Consumers Power Company
Palisades Plant
Docket 50-255

PROPOSED TECHNICAL SPECIFICATIONS PAGE CHANGES

September 1, 1988

FIGURE 3.23-1 ALLOWABLE LHR AS A FUNCTION OF PEAK POWER LOCATION

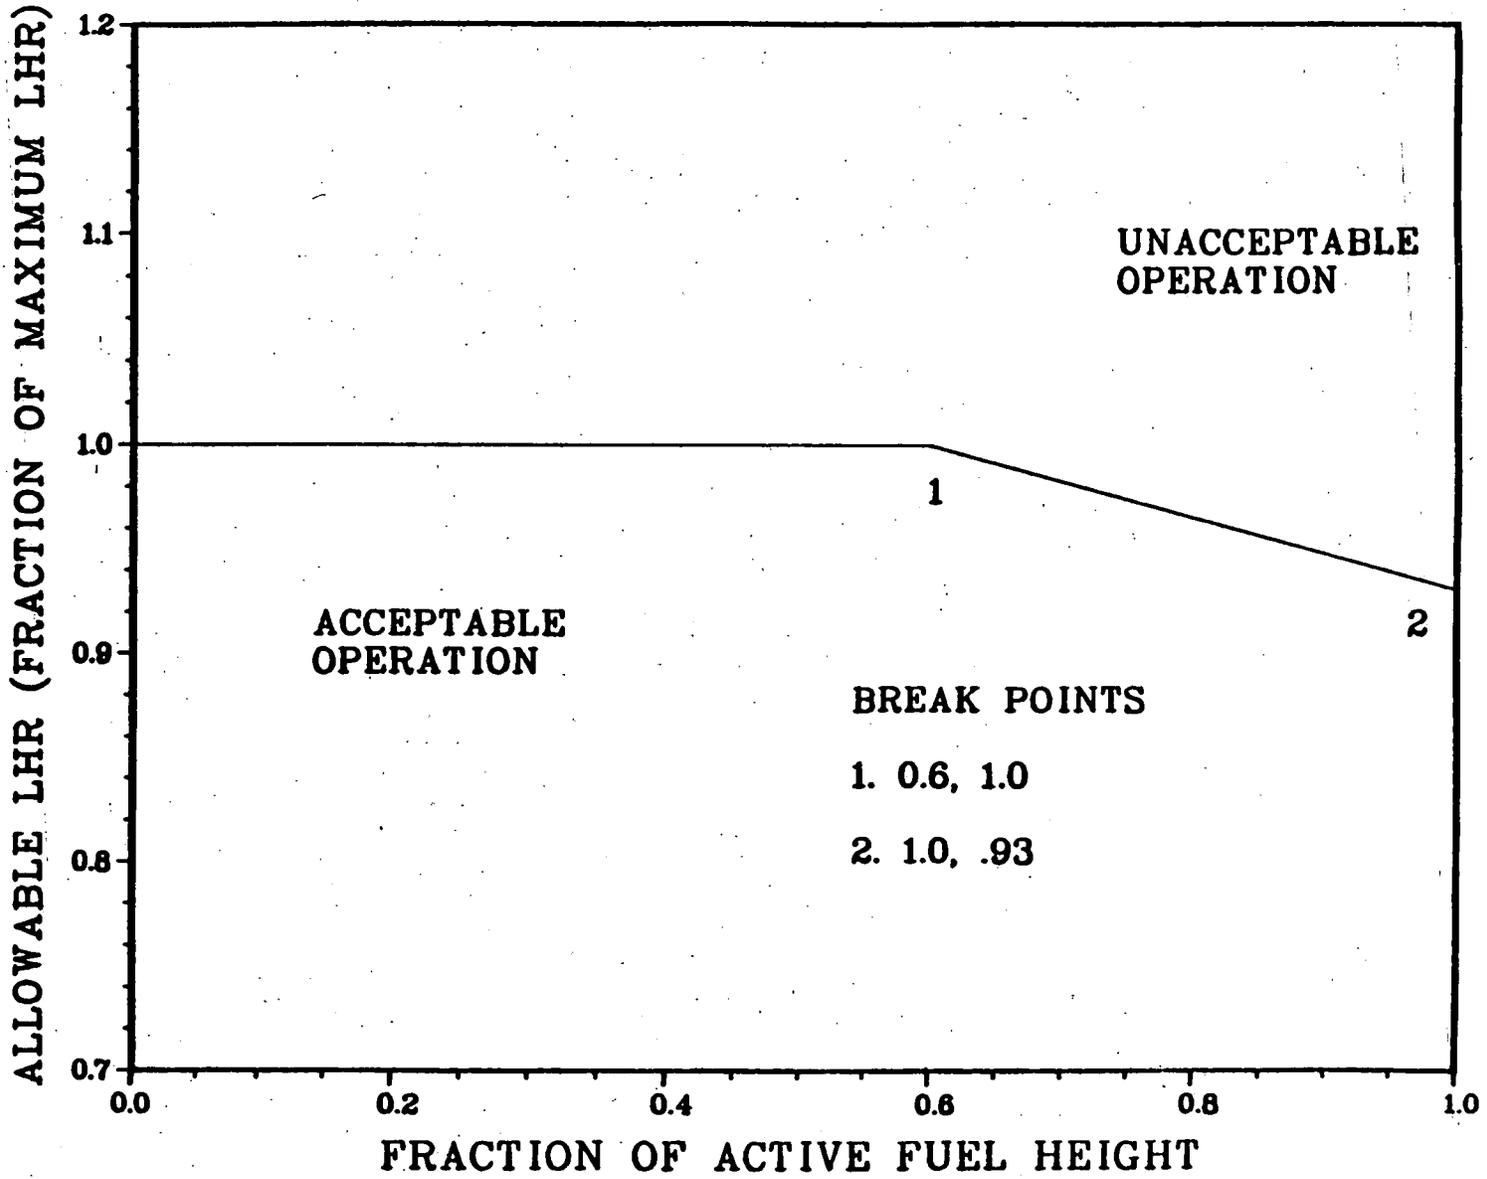
The LHR in the peak power fuel rod at the peak power elevation Z shall not exceed the value in Table 3.23-1 times $F_A(Z)$ [the function $F_A(Z)$ is shown in Figure 3.23-1].
